**DEALER NOTIFICATION LETTER  
SAFETY RECALL AMG R0601  
STEERING GEAR ATTACHMENT**

## PRODUCT RECALL BULLETIN

Subject: PRODUCT RECALL AMG R0601 STEERING GEAR ATTACHMENT

Models Affected: MODEL YEAR 2006 ALPHA VEHICLES WITH VIN

Figure 1: Steering Gear Attachment Hardware

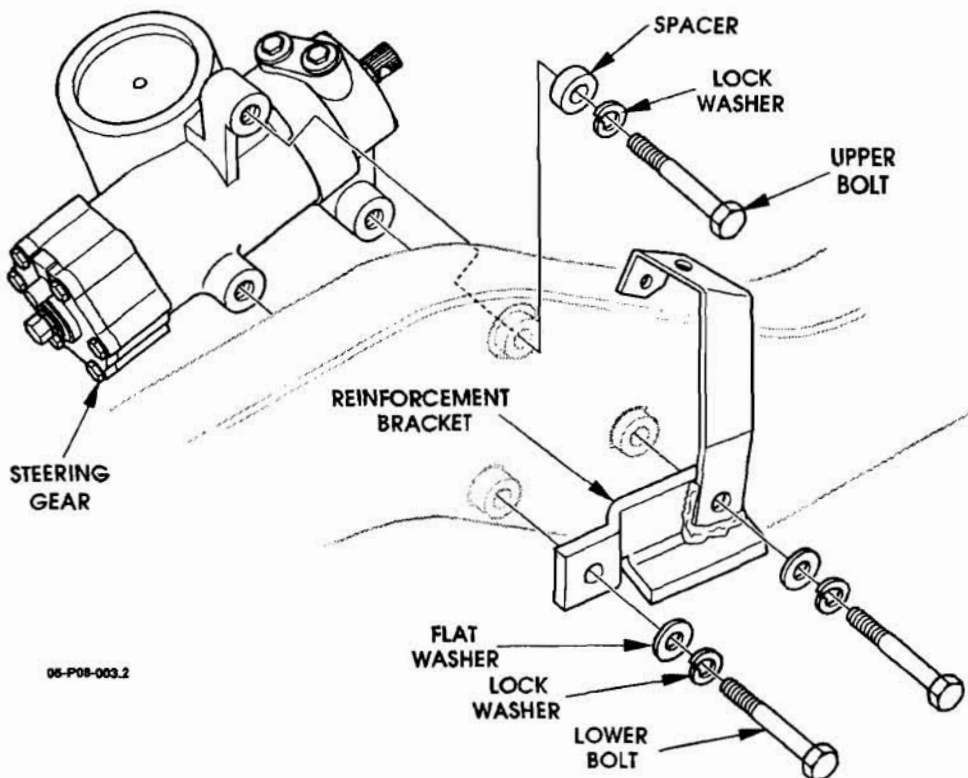
1. Perform a visual inspection of the hardware attaching the steering gear to the frame. The **upper bolt** requires a spacer and a split lock washer (See Figure 1). Both **lower bolts** use only a flat washer and a split lock washer.
2. If the spacer and washers are in the correct positions, apply 175 lb-ft. (237 N·m) of torque to all three bolts.
3. If any of the bolts rotate before the torque value is attained, remove all the bolts and clean all thread locking compound from the gear and the bolts.
4. Apply Loctite 242, or equivalent medium strength thread locker to the threads, place the spacer and washers on the bolts in the positions shown below and torque the bolts to 175 lb-ft. (237 N·m).

1. If the spacer and washers are not in the correct positions, replace the steering gear and hardware (See Service Manual Section 8). Torque the bolts to 175 lb-ft (237 N·m).
